CONSTRUCTION PLANS FOR CARRIAGE MEADOWS SOUTH AT LORSON RANCH

STREET, STORM SEWER, AND POND CONSTRUCTION PLANS

COVER SHEET
STREET, STORM SEWER AND POND
CONSTRUCTION PLANS

SHEET NUMBER: C10.1

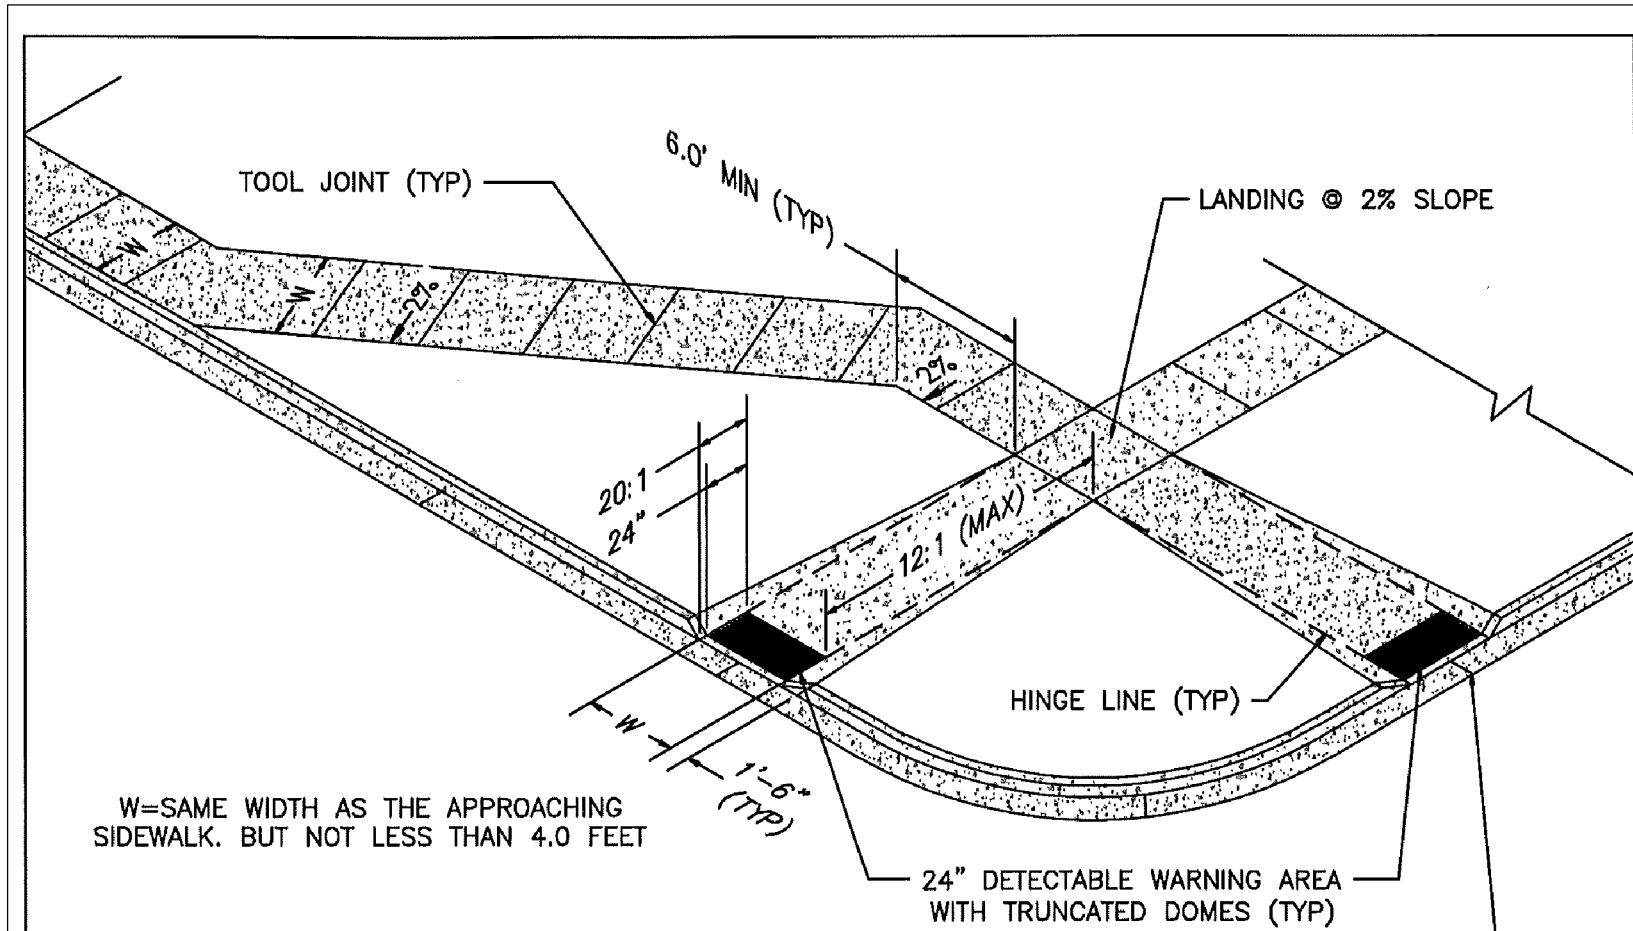
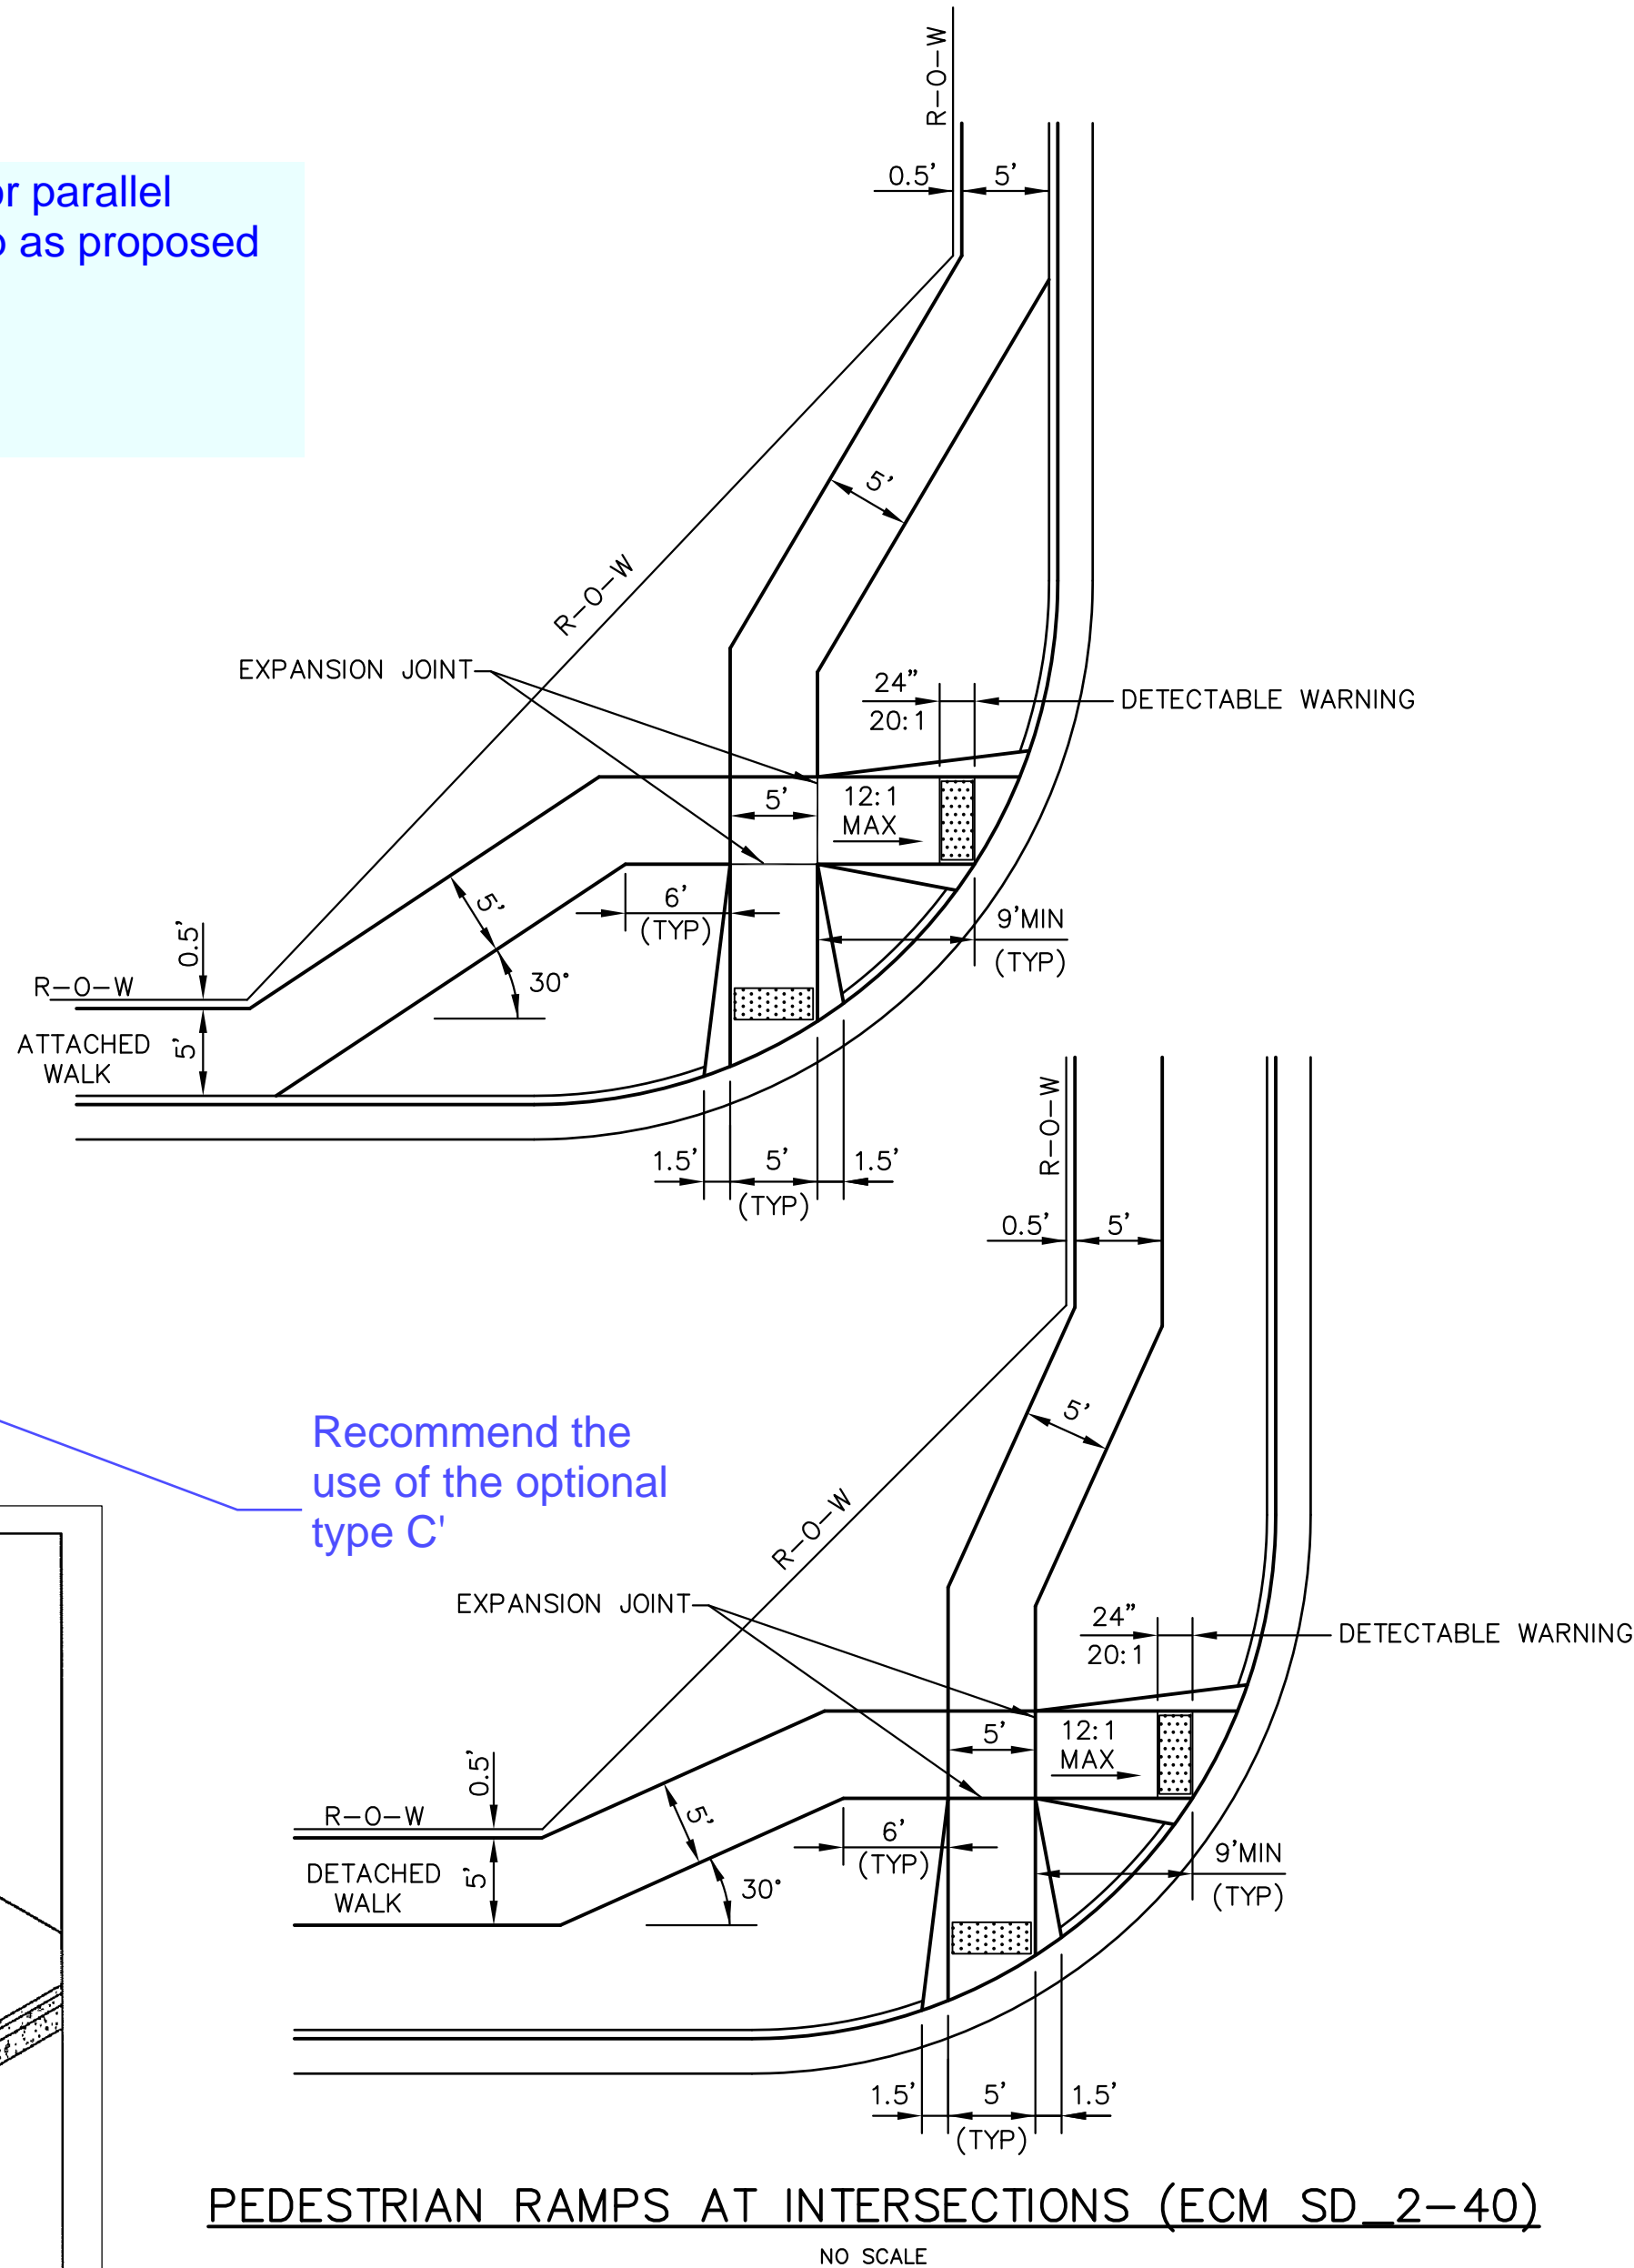
Provide detail for parallel pedestrian ramp as proposed in this plan set.
